# UNITED STATES PATENT AND TRADEMARK OFFICE

**Office Action Summary**

This is the first Office Action for serial number 10/016,574, Universal camera mount, filed on December 7, 2001. Claims 1-18 are pending.

FIG. 1

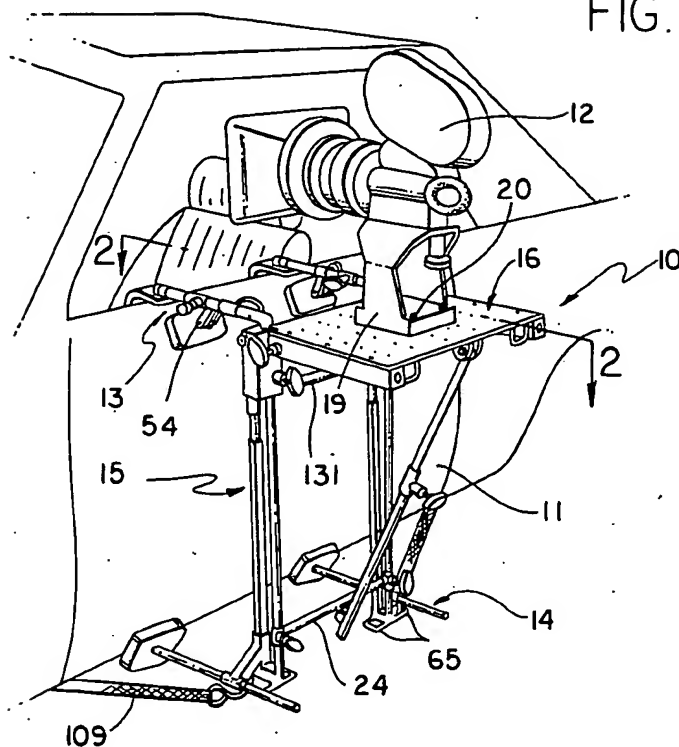
Claims 1-18 are rejected under 35 U.S.C. 103(a) as being unpatentable over U.S. Patent 4,615,597 to Burriss in view of U.S. Patent 6,380,855 to Ott and further in view of U.S. Patent 5,565,848 to Leyden et al. (Leyden). With regards to claims 1-18, Burriss discloses a mount assembly (see attached marked copy of Fig. 2) comprising: a mounting member (16) including an upper surface, a lower surface, a sensor region (B) including apertures (18), a first plurality (A) of apertures (18) arranged in a first aperture region on one side of the sensor region (B), a second plurality (C) of apertures (18) arranged in a second aperture region on an opposite side of the sensor region (B); the first and second plurality of apertures (A, C) being adapted for engagement with

threaded fasteners (20) to secure an article (12) thereto and each comprising at least three apertures with at least one of the three apertures not in linear alignment with at least two of the other at least three apertures, the first and second plurality of apertures (A,C) including a two dimensional array of at least two rows of apertures and at least two columns of apertures, each of the at least three apertures extending from the upper surface to the lower surface for restrainable yet reorientable attachment of the mounting member (16) to an article (12); the reorientable attachment extending into at least two substantially intersecting directions of movement amongst each of first and second aperture regions for mounting the article in at least one preferred attachment position in at least one of the first and second aperture regions. Burriss does not disclose the apertures (18) being threaded. However, it would have been obvious to one of ordinary skill in the art at the time the invention was made to have modified the apertures to be threaded as a well-known alternative means for securing threaded fasteners therein. Burriss does not disclose the mount assembly including an anti-theft sensor attached thereto or the article being secured to the mount by a secondary fastener. Ott teaches a mount assembly comprising an anti-theft sensor (59,61,65,63) for contacting an article (12) to be monitored, the sensor being attached to a mounting member (14,40) having double sided adhesive on a top surface thereof for securing to the article. It would have been obvious to one of ordinary skill in the art at the time the invention was made to have modified the mount assembly to include an anti-theft sensor attached to the mounting member for contact with the article because one would have been motivated to safeguard the article against theft as taught by Ott (Abstract, lines 1-3). Additionally,

Burriss in view of Ott as applied above does not disclose the anti-theft sensor including a housing fixedly attached to the mounting member. Leyden teaches an anti-theft sensor (Fig. 1) comprising: a housing (at 18) having an interior region and an upper surface (28) having double-sided adhesive (30) thereon, the housing configured to be fixedly attached to a mount; a biased switch member (22; col. 5, lines 4-5) for contacting an article to be monitored, the switch oriented substantially normal to the external surface of the article; an electronic circuit board contained within the interior region of the housing (col. 5, lines 12-14); a signal (14) indicating the presence or absence of operable monitored contact between the switch member (22) and article surface; and a signal transmission medium (20). It would have been obvious to one of ordinary skill in the art at the time the invention was made to have modified the mount assembly of Burriss in view of Ott by substituting the sensor of Leyden as an equivalent, alternative anti-theft mechanism as inherently taught by Leyden. Regarding claim 17, Burriss in view of Ott in view of Leyden does not disclose the anti-theft sensor fixedly attached to the mounting member by a fastener having a threaded shank. However, it would have been obvious to one of ordinary skill in the art at the time the invention was made to have modified the mounting assembly by securing the anti-theft sensor to the
